**Stage 1 Road Safety Audit**  
**Reeds Lane, Sayers Common**  
**Proposed Development Access Proposals**

**Date:** 16/12/2025

**Reference:** RSC/KS/EB/25031

## APPENDIX B: Drawing Showing Problem Locations

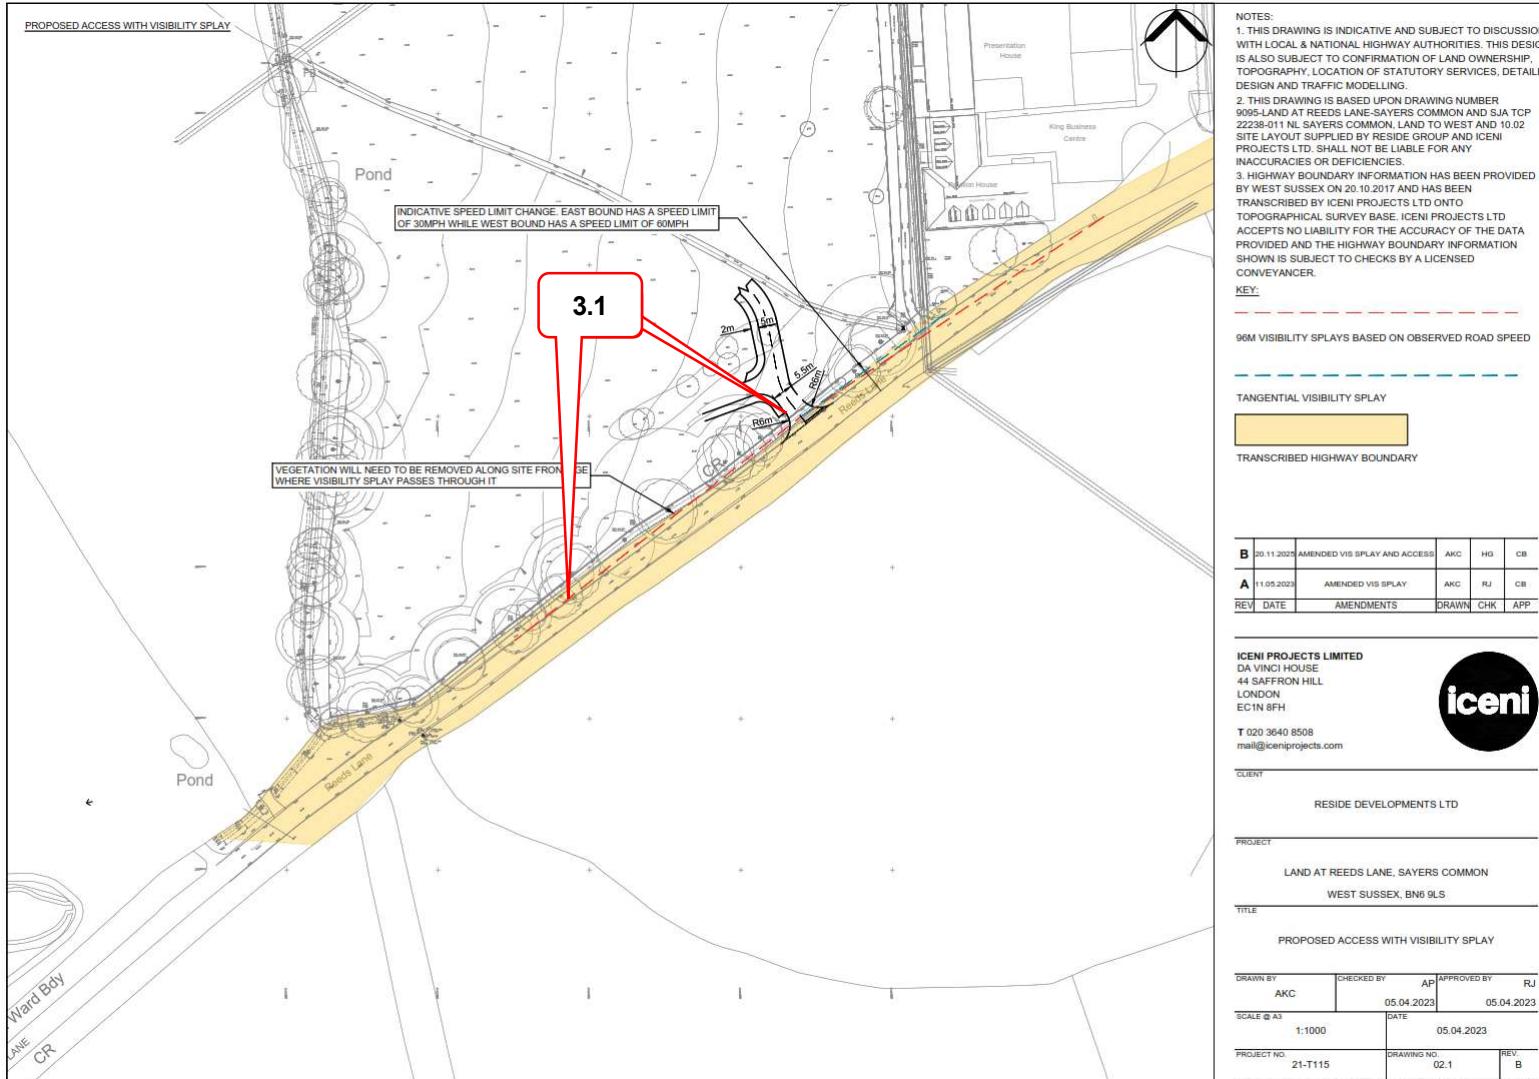
Location: Reeds Lane at the development access

Summary: Inadequate side road visibility may lead to pull-out failure to give way type collisions

At the development access, side road visibility may be restricted by vegetation. Inadequate side road visibility may lead to pull-out failure to give way type collisions.

The existing speed limit terminal from 60mph to 30mph is located to the east of the proposed development access and eastbound approach vehicle speeds are likely to remain high due to the rural nature of Reeds Lane west of the proposed development access; this may exacerbate the issue above.

It is recommended that adequate side road visibility is provided for users. The visibility splay should be consistent with off-peak free flow 85<sup>th</sup> percentile speeds and be free of any obstruction. This may require the removal of vegetation and trees within the splays. See also paragraph 2.3.1 above.

As the development extends the built-up area of the village, it would be appropriate to relocate the speed limit terminal to co-ordinate with the proposed site extents of the built-up area to the west of the access.

Effective speed management measures should be introduced to encourage compliance with the relocated speed limit terminal. Measures may include the provision of an effective gateway feature at the speed limit terminal and the extension of street lighting.

Prob No:	Location / Summary	Recommendation (summary)	Design Organisation Response	Overseeing Organisation Response	Agreed Action in Response to RSA
3.1	<b>Location: Summary:</b>	<p>It is recommended that adequate side road visibility is provided for users. The visibility splay should be consistent with off-peak free flow 85<sup>th</sup> percentile speeds and be free of any obstruction. This may require the removal of vegetation and trees within the splays. See also paragraph 2.3.1.</p> <p>As the development extends the built-up area of the village, it would be appropriate to relocate the speed limit terminal to co-ordinate with the proposed site extents of the built-up area to the west of the access.</p> <p>Effective speed management measures should be introduced to encourage compliance with the relocated speed limit terminal. Measures may include the provision of an effective gateway feature at the speed limit terminal and the extension of street lighting.</p>	Vegetation is to be cutback and maintained. Visibility has been checked and can be delivered.
